MODIFICATION SHEET NO. RDSO/2009/EL/MS/0377 (Rev.0) , Dated 22.04.09.

Modification to voltage sensing circuit in WAP-5,WAP-7,WAG-9 & WAG-9H Locomotives.

OHE VOLTAGE SENSING CIRCUIT (MODIFIED)

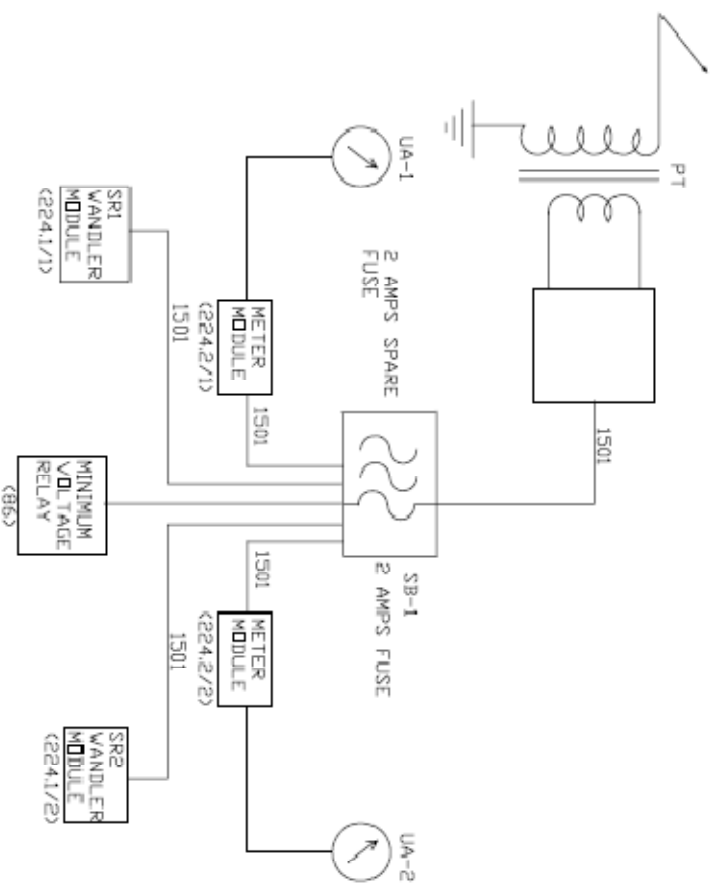
A 2 Amps fuse is relocated to SB-1 in the locomotives provided with 2 Amps fuse in the secondary of potential transformer. In the old locomotive also where no fuse is provided on the secondary side of potential transformer on roof, one 2 Amps fuse should be provided in SB-1. Two spare fuse of 2 Amps should also be provided near the working fuse. The photograph of arrangement of the 2 Amps fuse in SB-1 cubicle is enclosed.

Modified circuit diagram is attached .
